SUBJECT: ISSUANCE OF AMENDMENT NO. 46 TO FACILITY OPERATING LICENSE NO. NPF-63 REGARDING ADDITIONAL CHANGES RELATED TO CYCLE 6 FUEL TRANSITION FOR SHEARON HARRIS NUCLEAR POWER PLANT, UNIT 1 (TAC NO. M87298)

SHEARON HARRIS NUCLEAR POWER PLANT, UNIT 1

SAFETY EVALUATION BY THE OFFICE OF NUCLEAR REACTOR REGULATION
RELATED TO AMENDMENT NO. 46 TO FACILITY OPERATING LICENSE NO. NPF-63

**FIGURE 2.1-1
REACTOR CORE SAFETY LIMITS - THREE LOOPS IN OPERATION**

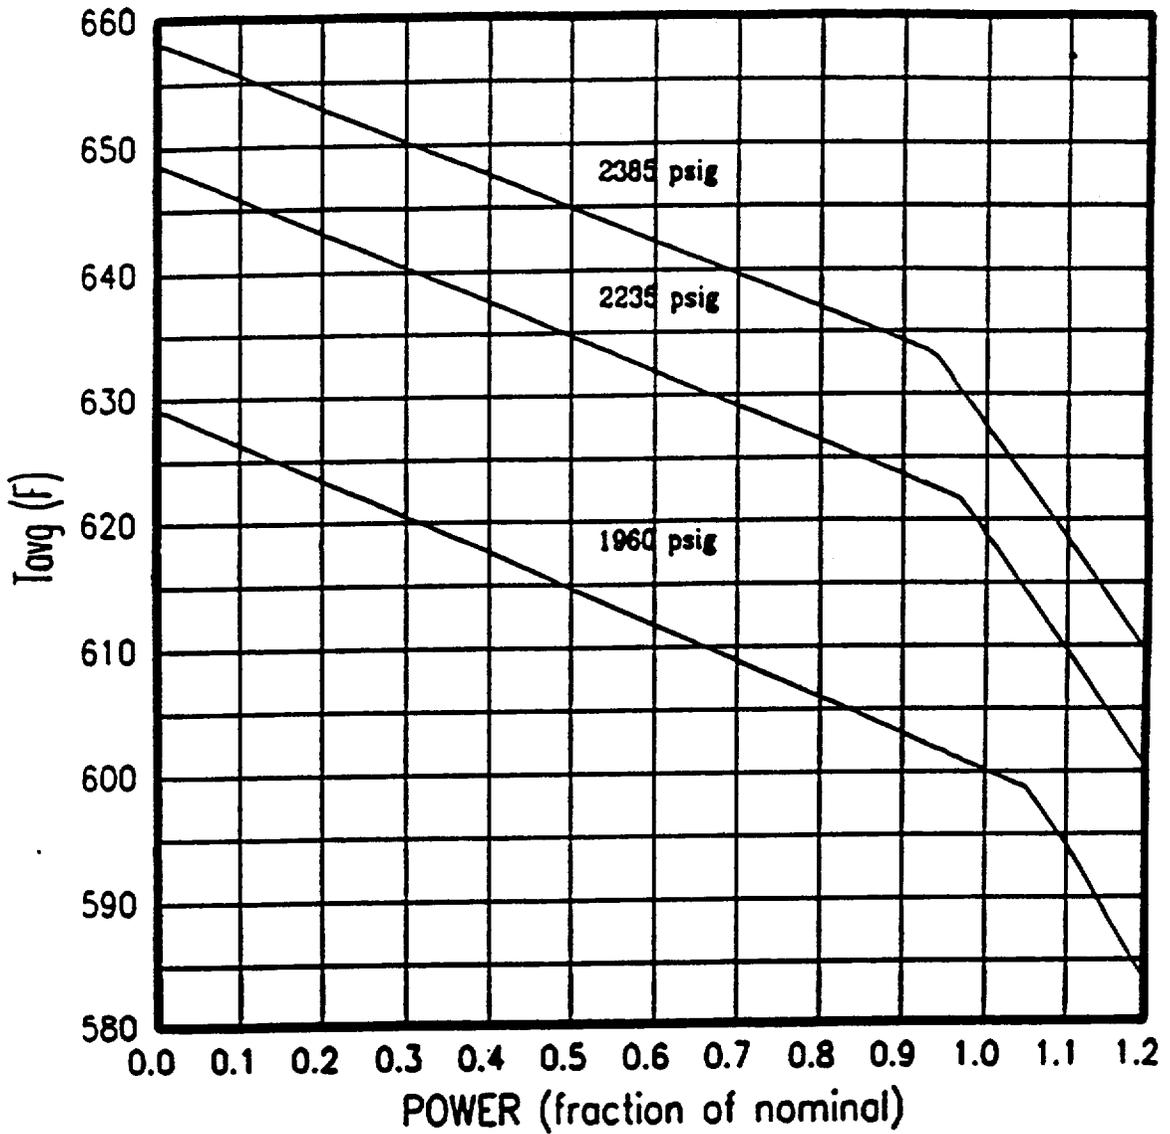
(a) Specification 2.1.1, Figure 2.1-1, "Reactor Core Safety Limits - Three Loops in Operation"

The existing Figure 2.1-1 was developed by Westinghouse for a core composed of only Westinghouse fuel assemblies. These curves have been revised for the Cycle 6 core which is composed of both Siemens HTP and Westinghouse Vantage 5 and LOPAR fuel assemblies. The new set of reactor safety limit curves have been established for the transition core using the approved Siemens HTP correlation.

The Bases associated with this Specification have also been revised to reflect the use of a transition core and the use of Siemens methodologies.

The staff has reviewed this TS change and associated Bases related to the transition and finds that the proposed TS change is acceptable since the approved methodologies are used and the departure from nucleate boiling ratio (DNBR) uncertainty is no longer applicable to the SHNPP Cycle 6 operation.
